DA 10.2018.650.1 Mixed use development, Jonson Street, Byron Bay

ATTACHMENTS TO COUNCIL REPORT

ADDENDUM 1: SUMMARY FOR RESPONSE TO COUNCIL'S INFORMATION REQUEST – DECEMBER 2018

ADDENDUM 2: SUMMARY FOR RESPONSE TO COUNCIL'S INFORMATION REQUEST – MAY 2019

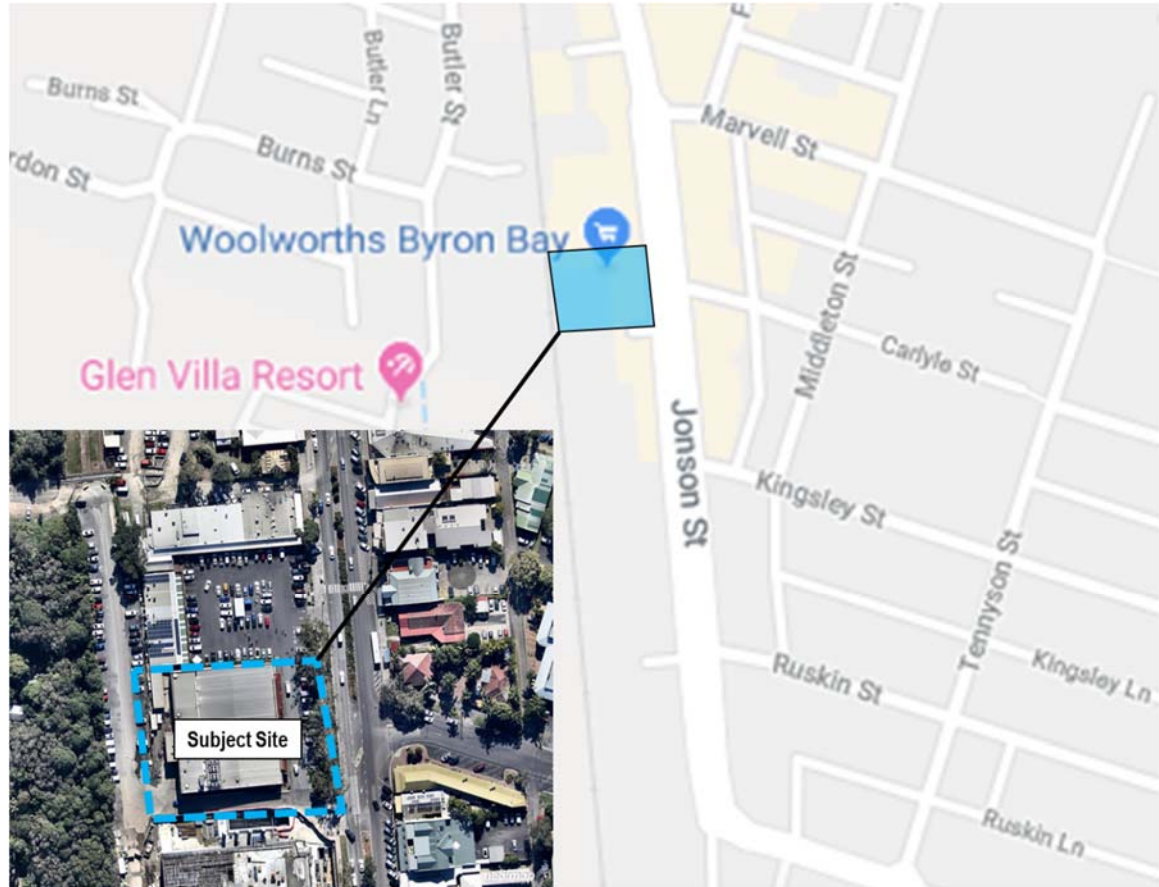
Provide efficiency and safety assessment addressing the mix of passenger and commercial traffic utilising the common internal access area and the drop-off & set down area of the hotel. Commercial traffic should be isolated / separated from passenger traffic.

An assessment of potential vehicle conflicts has been conducted, please refer to Section 4.5.3 for further detail. As conflict will only occur between service vehicles, expected to occur relatively irregularly and outside of peak hours, and private vehicles using the porte-cochere, hotel guests at check-in only, the likelihood of vehicle conflict is considered minimal.

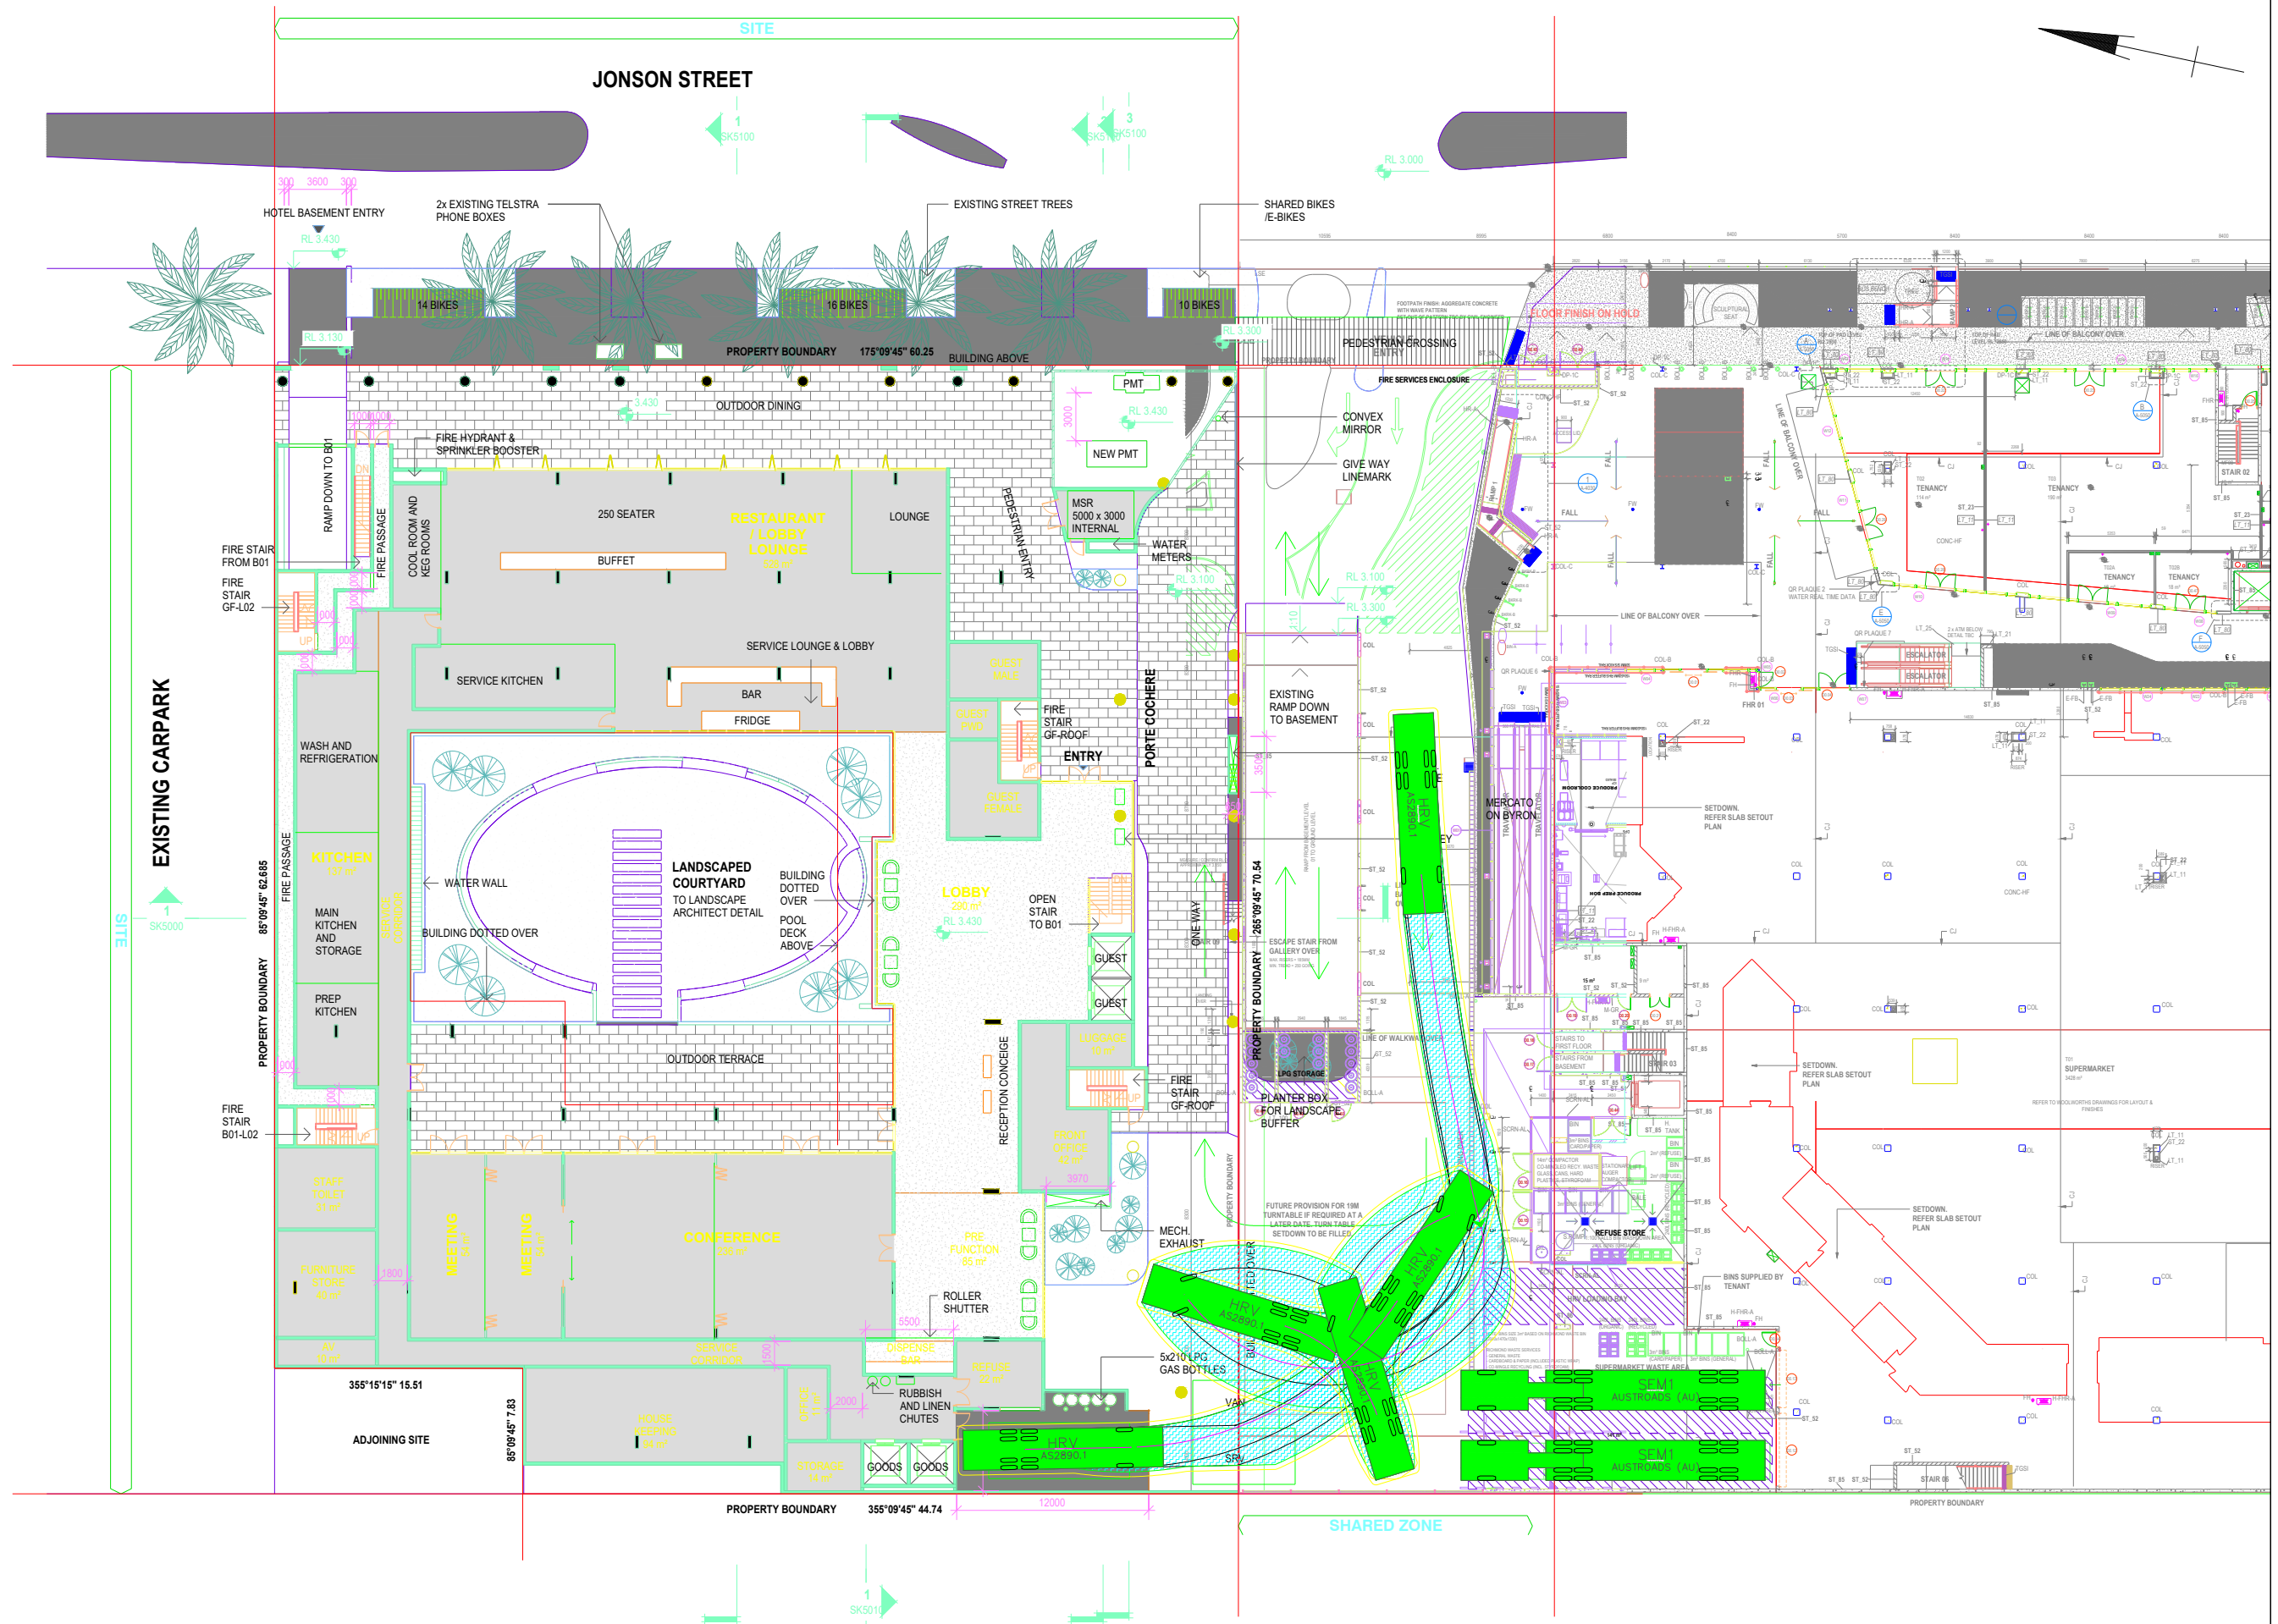
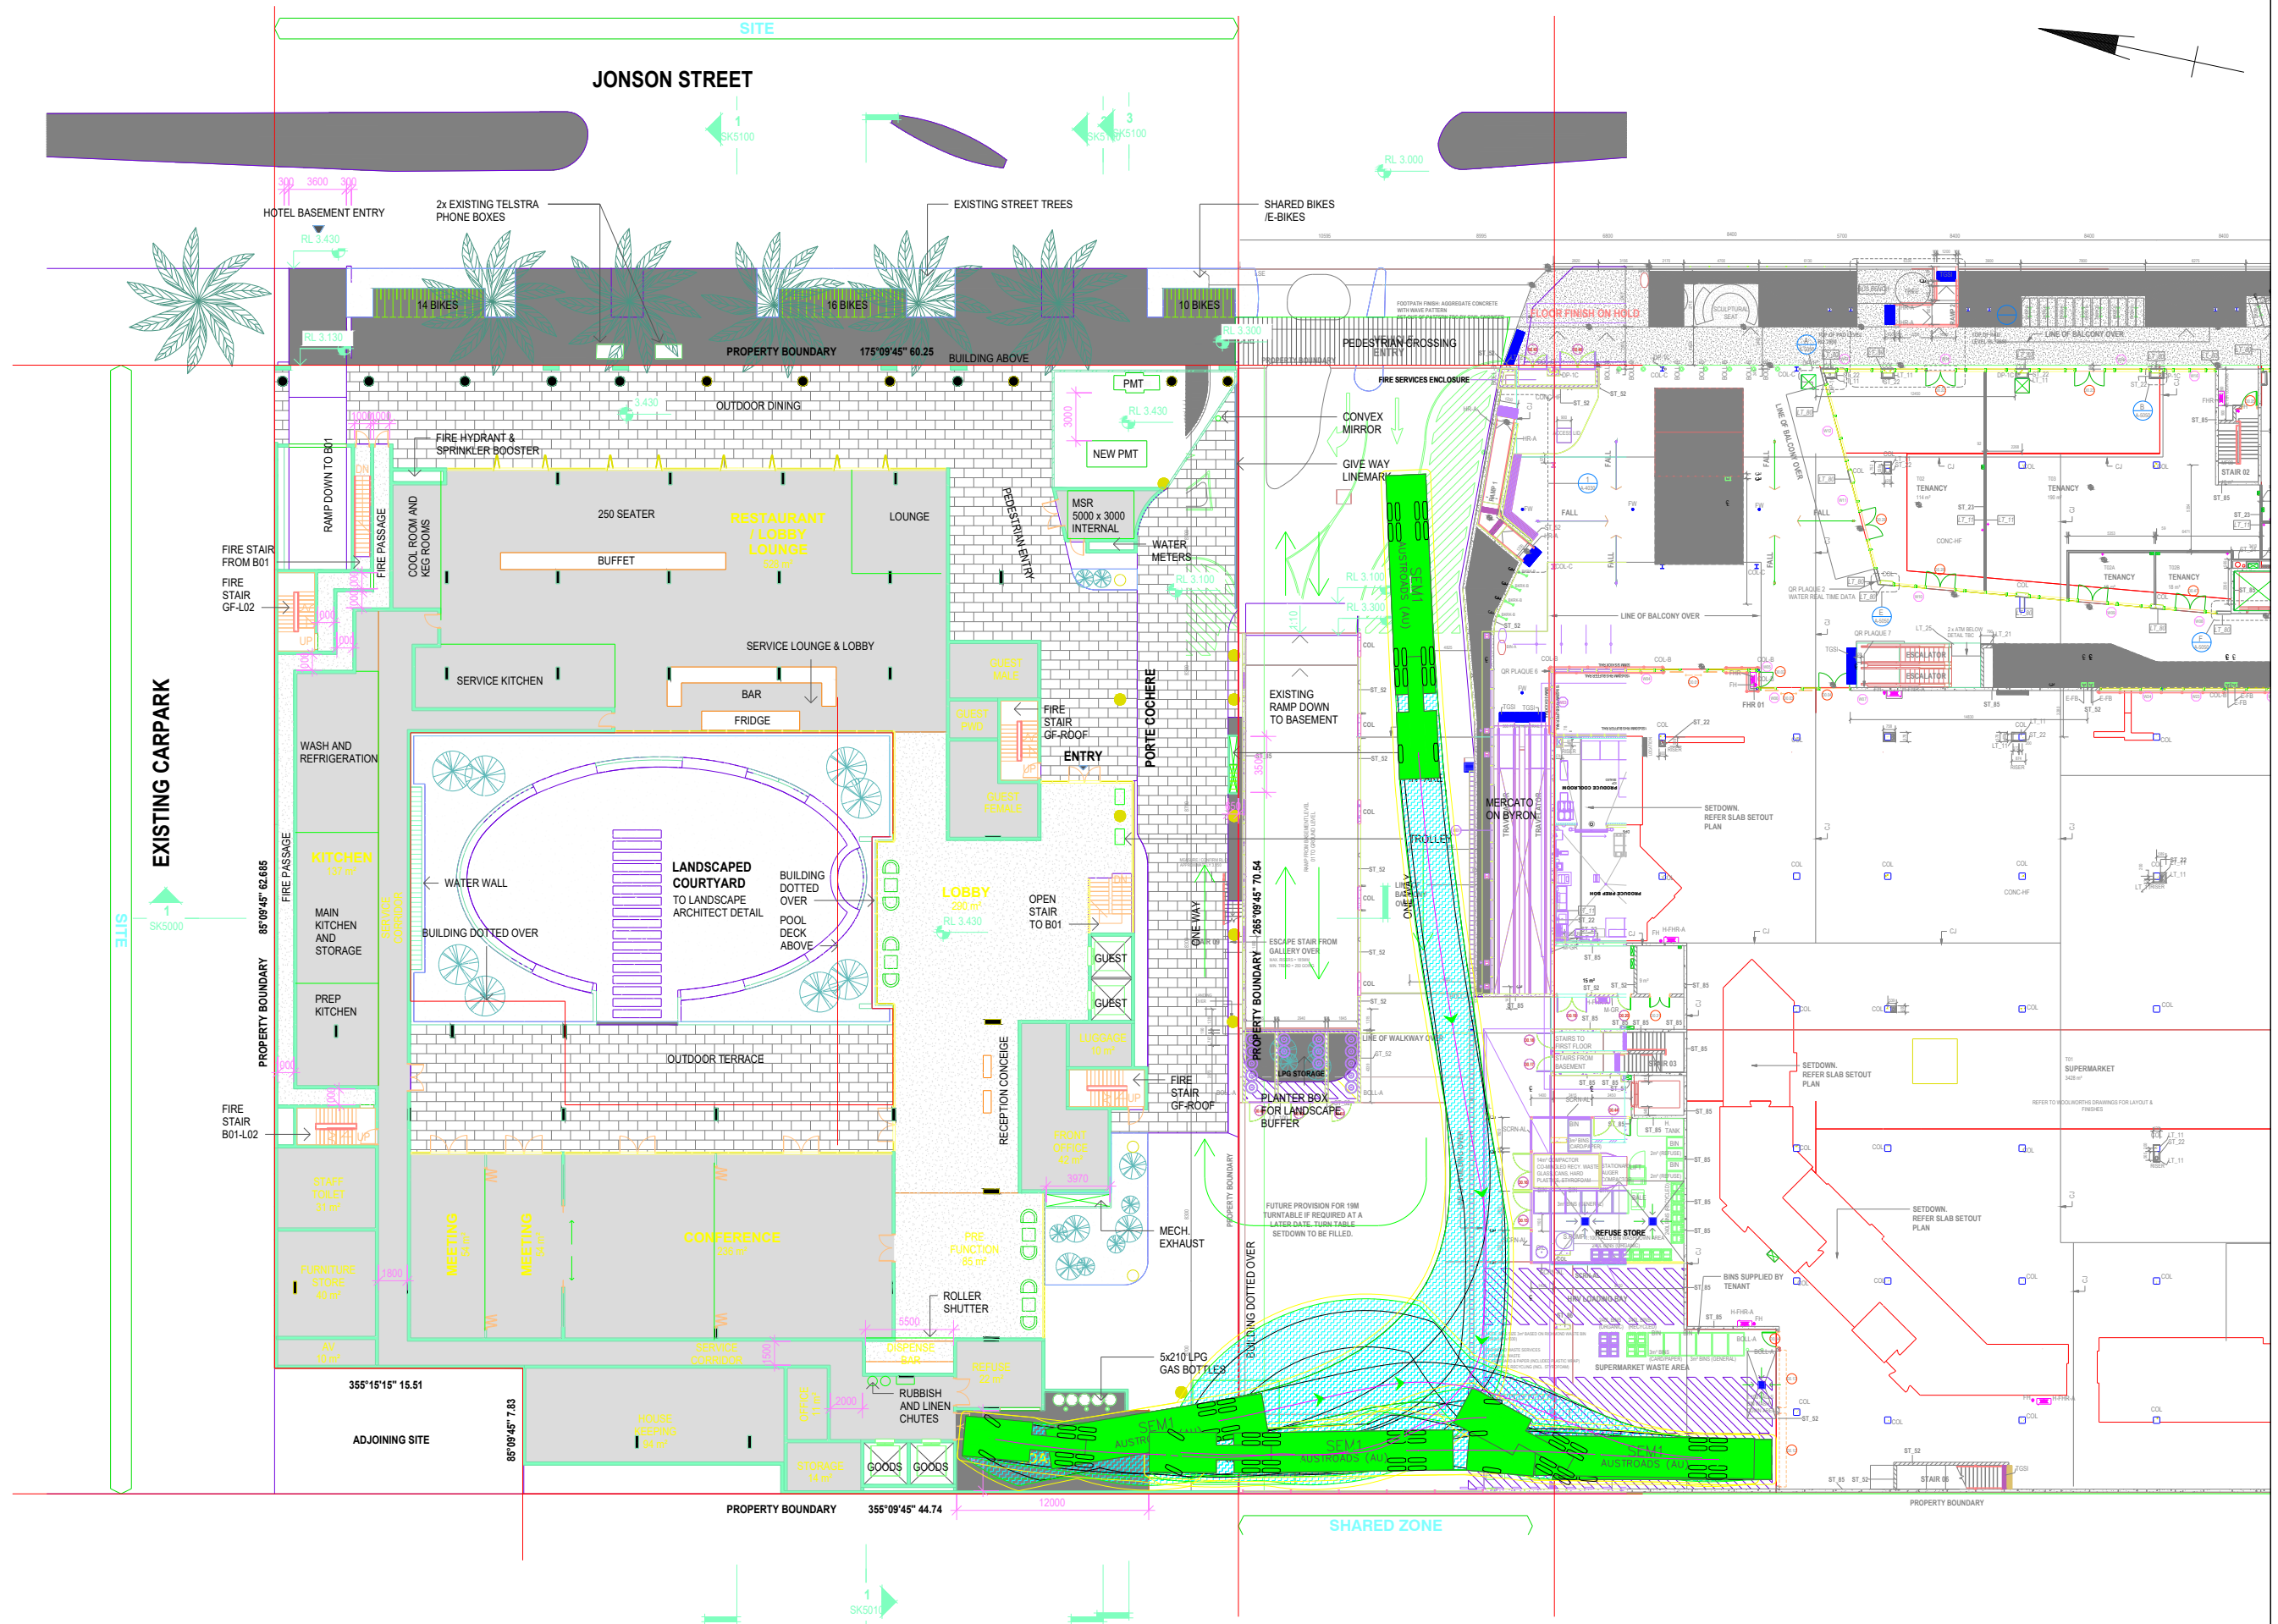
Provide all manoeuvring movements for the maximum sized vehicles at access points (entry & exit), loading bays and turnaround area within the development.

A swept path has been conducted for the site's access and manoeuvring areas for the site's design service vehicle (HRV), neighbouring site's design service vehicle (AV). Refer to Section 4.5.2 for further detail, with swept paths provided in **Appendix F**.
